Docket Item # 7 & 8  
BAR CASE # 2012-0202 &  
2012-0203

BAR Meeting  
July 11, 2012

**ISSUE:** Partial Demolition/Capsulation, Addition and Alterations

**LOCATION:** 204 South Saint Asaph Street

(B) EXISTING SOUTH ELEVATION  
1/4"=1'-0"

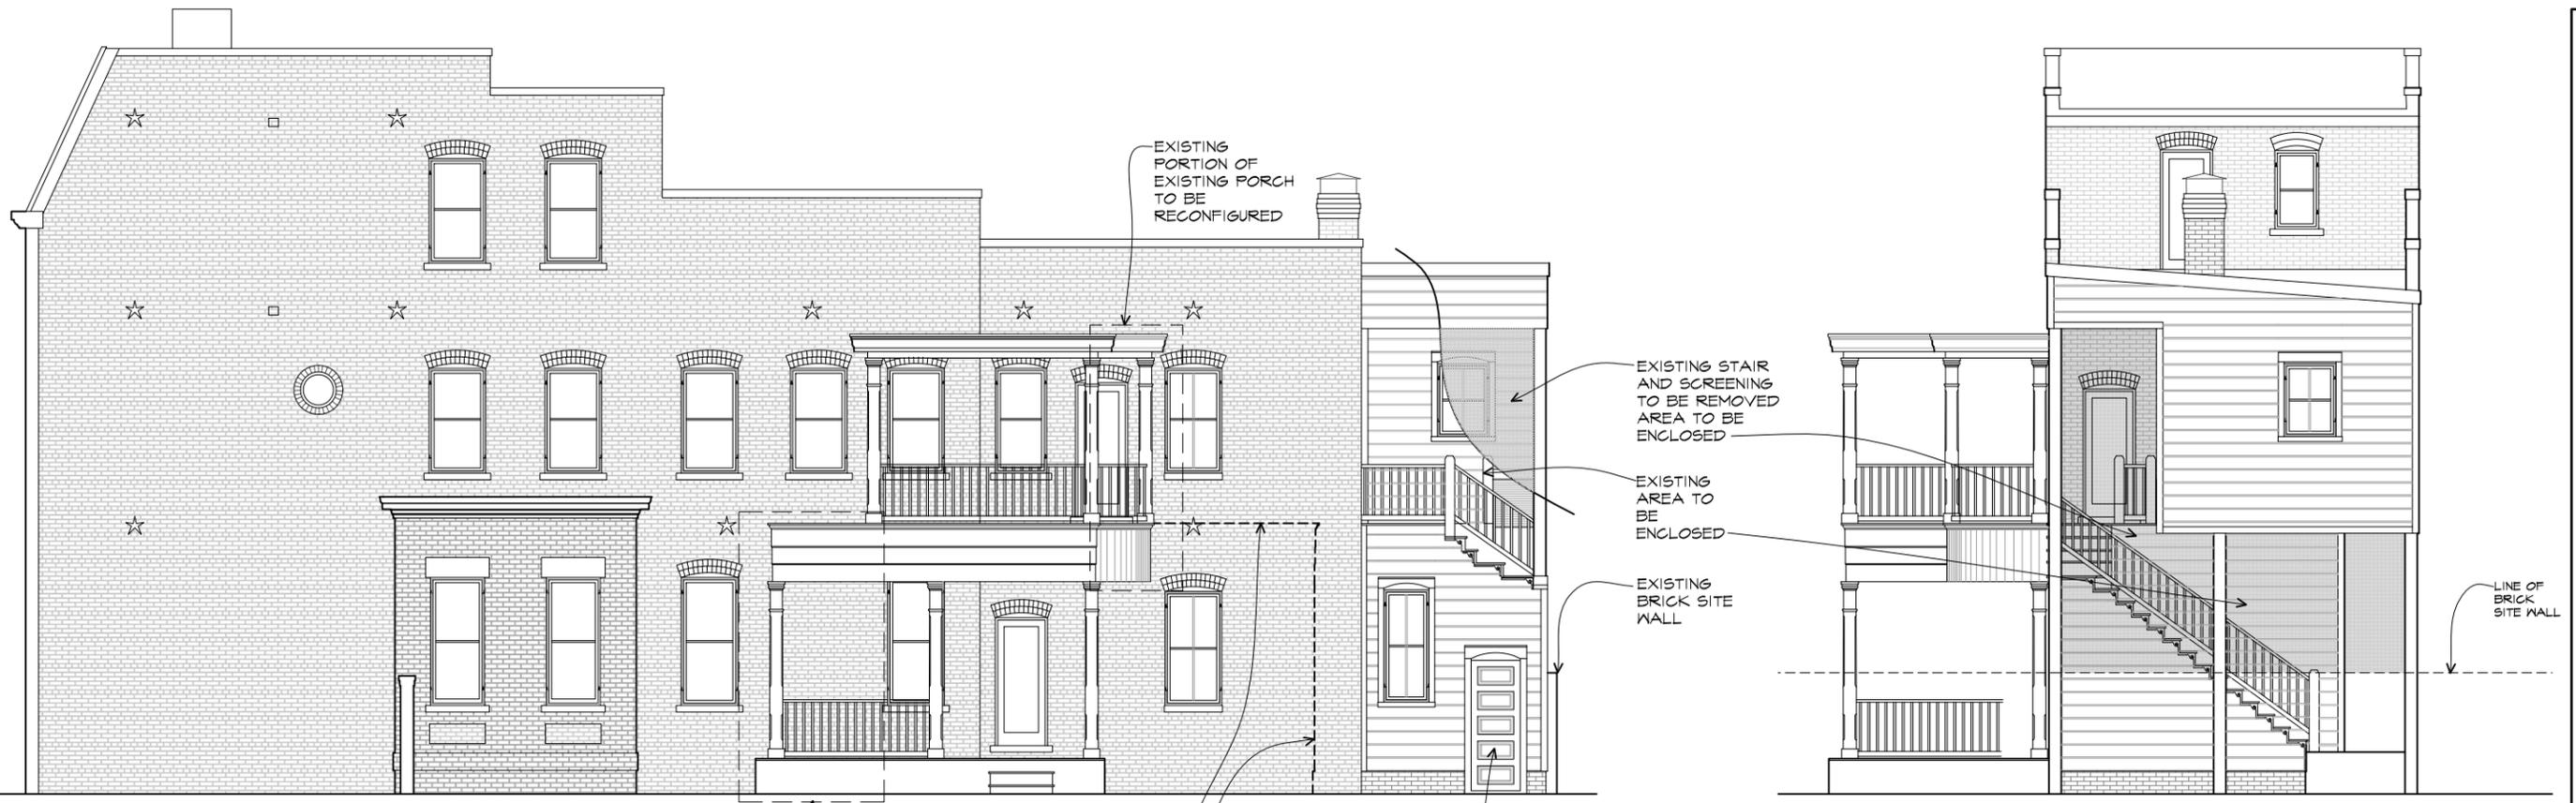
The applicant is requesting approval of a Permit to Demolish/Capsulate to partially demolish and capsulate portions of the south (side) and east (rear) elevation for a small addition and alterations. The proposal includes the following:

- Remove part (one-bay) of existing one-story porch on south (side) elevation.
- 3.5 foot by 10.75 foot one-story expansion with three two-over-two painted wood windows and panels directly east of existing covered porch at first story.
- Expand existing second story covered porch over first floor expansion.
- Remove existing door and replace with siding on existing rear porch at first story.
- Remove existing stair and single window and enclose second story space with three two-over-two painted wood windows.

In the opinion of Staff, the criteria to demolish and capsule are not met and the Permit to Demolish should be granted. The Board regularly approves the partial demolition and capsulation of secondary elevations or later additions to allow for a new or larger rear addition or other alterations when the existing walls are not of particularly old or unusual construction. In this case, the majority of the existing original elements will remain visible and intact. The majority of the area proposed for capsulation is on a two-story rear addition which was not original and has been clearly altered over time. Staff finds the cumulative amount of demolition and capsulation to be minimal in scope.

- C-6 The height of the porch above grade is not shown. If > 30" above finished grade porches must have guardrails on open sides. Guardrails and intermediate rails must comply with USBC.

(C) EXISTING EAST ELEVATION  
1/4"=1'-0"

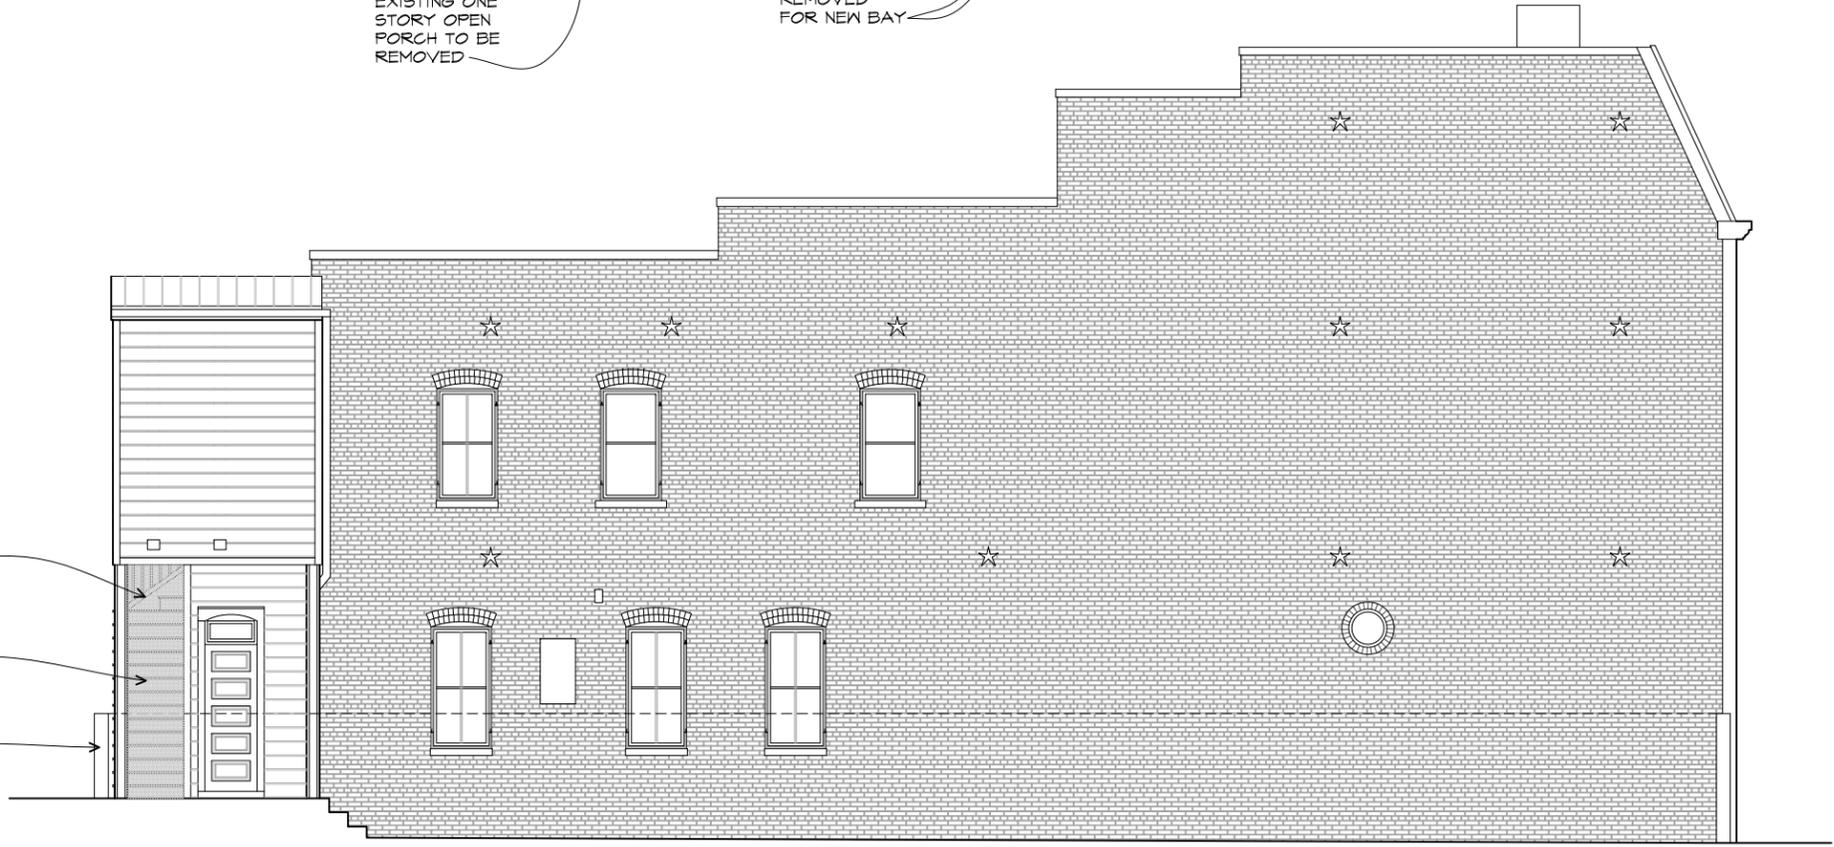
- Remove existing stair and single window and enclose second story space with three two-over-two painted wood windows.
- Enclose open portions with wood siding to match existing.

(B) NEW SOUTH ELEVATION  
1/4"=1'-0"

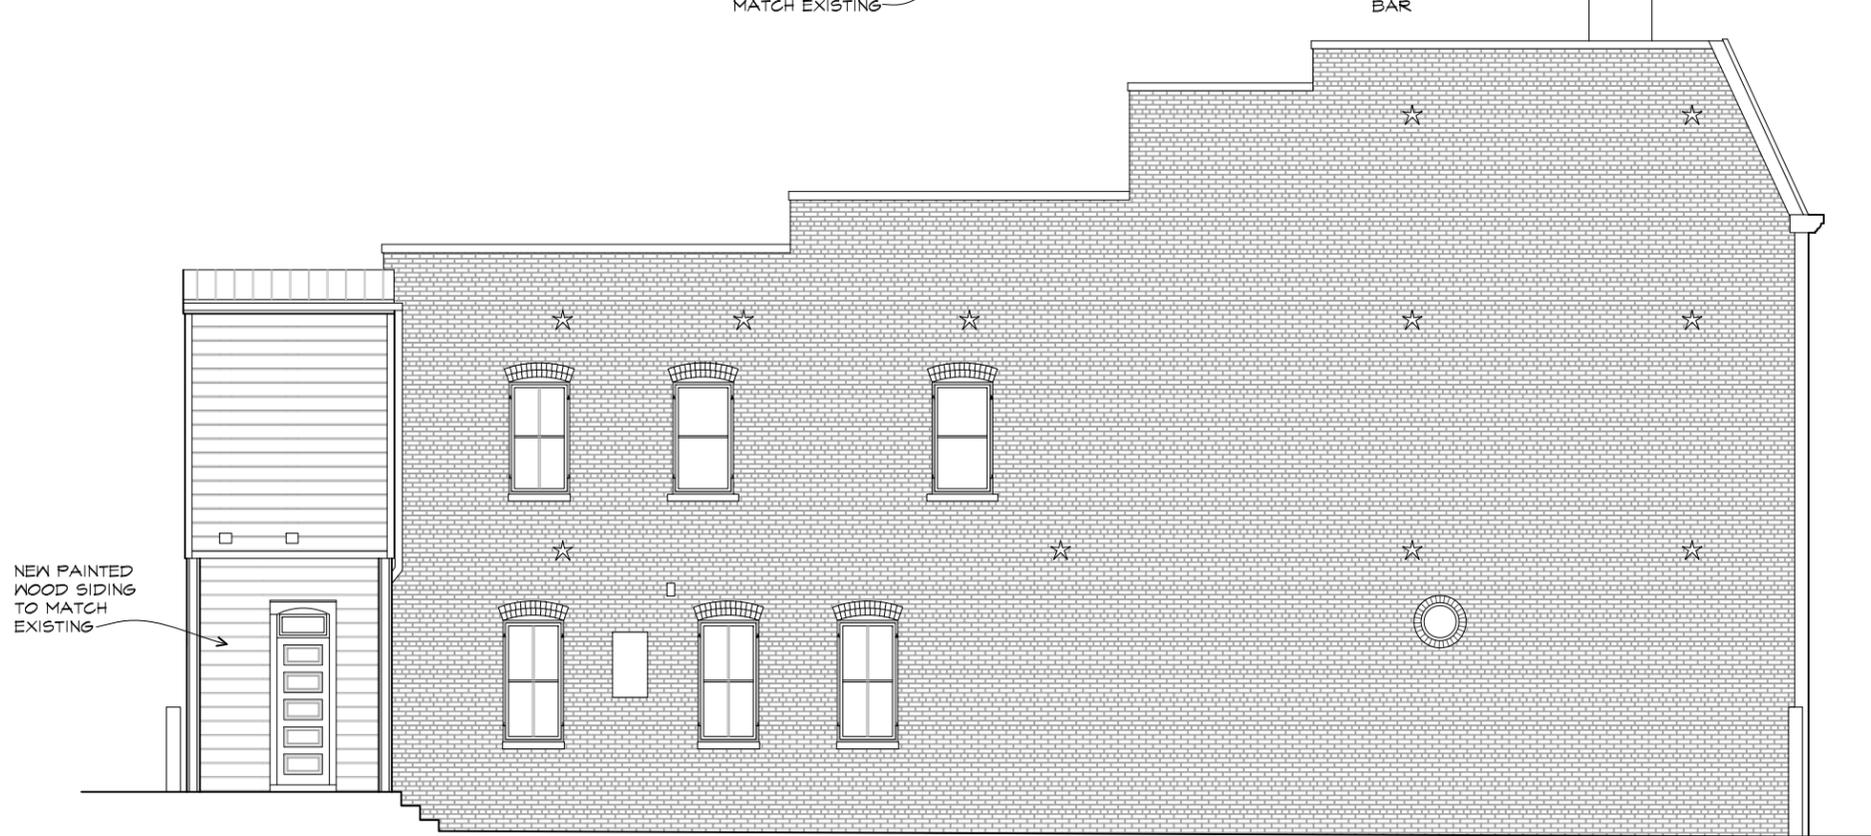
The proposed addition is one of the smallest that the Board has reviewed and will be minimally visible from South Saint Asaph Street, as the existing townhouse is mid-block and the addition will be located behind an open two-story porch. When considering any addition, the Board must consider not only the impact of the addition on the existing building but also on the surrounding area. The alterations to the rear frame addition are appropriate and stylistically consistent with a rear addition or porch such as this. Staff finds the addition and alterations to be compatible with respect to scale, mass and architectural character as the proposal allows the historic freestanding townhouse to remain prominent.

The proposed materials — wood siding and trim, wood windows and columns — are all considered by BAR policies appropriate materials for new construction.
